UN/CETDG/21/INF.46

Development of Provisions for the Transport of Gases

Comments on the work of the Working Group on Gas Receptacles and Multiple-Element Gas Containers (MEGCs)

Transmitted by the expert from the United States of America

The refillable pressure receptacle markings shall be applied as shown in the following examples:

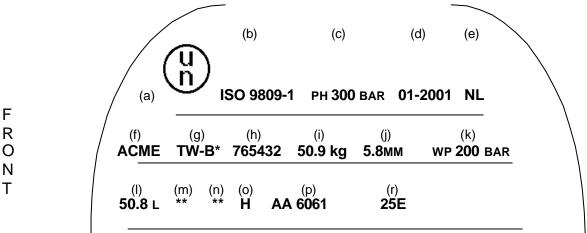
The expert from the United States generally agrees with the marks agreed to by the working group at its previous session. In ST/SG/AC.10/2000/38, the expert from France has proposed that, for marking requirements only a reference to the ISO standard on cylinder stamp marking be included. However, this is not an option because ISO 13769 is still a draft document that will not be published by the end of 2000 and because there are fundamental flaws in the sequence that is indicated and with some of the marks specified. However, we believe that in order to facilitate international acceptance of UN marked pressure receptacles the location and size of the markings need to be consistently indicated on each and every UN pressure receptacle. On this basis, the Model Regulations should indicate the exact location and size of the markings. The expert from the United States does not support the agreements reached by the technical committee responsible for developing ISO 13769 at its recent meeting in Tampa Florida and believes that the technical committee should not have advanced the standard to the FDIS stage since there was a lack of consensus on many of the marking issues. There are several countries that have expressed dissatisfaction with the progress and direction of the ISO 13679 development. Japan, Canada and the United States which comprise a large portion of pressure receptacle users and manufacturers have expressed major reservations regarding the stamp markings proposed in the ISO draft standard. The expert from the United States believes that the marks agreed to by the working group are more acceptable and should be maintained. While, the United States can agree to presenting the marks in a format more consistent with that presented in ISO/DIS 13679, it does not agree that the order of information indicated in the ISO/DIS is in the most logical sequence and that it is in the best interest of safety especially with respect to users and fillers. Furthermore, on the basis that we are proposing that acetylene cylinders not be addressed during this biennium, the United States is proposing to defer adoption of acetylene cylinder marks to provide more time to consider them and to address the wide divergence of opinions. The proposed acetylene markings also do not correspond with those specified in ISO 3807. The text provided below is the revised text for section 6.2.2.6 including revised marking examples for refillable and non-refillable cylinders:

6.2.2.6 Marking of refillable pressure receptacles

UN certified refillable pressure receptacles shall be marked clearly and legibly with certification and gas or pressure receptacle specific markings. These markings shall be permanently affixed (e.g. stamped, engraved, or etched) on the pressure receptacle. The markings shall be on the shoulder, top end or neck of the pressure receptacle or on a permanently affixed component of the pressure receptacle (e.g. welded collar). Except for the UN mark, the minimum size of the markings shall be 6mm for pressure receptacles with a diameter greater than 100 mm and 3mm for pressure receptacles with a diameter less than or equal to 100 mm. The minimum size of the UN mark shall be 12mm for pressure receptacles with a diameter greater than 100 mm and 6mm for pressure receptacles with a diameter less than or equal to 100 mm.

The following markings shall appear in the sequence as listed below from (a) to (r):
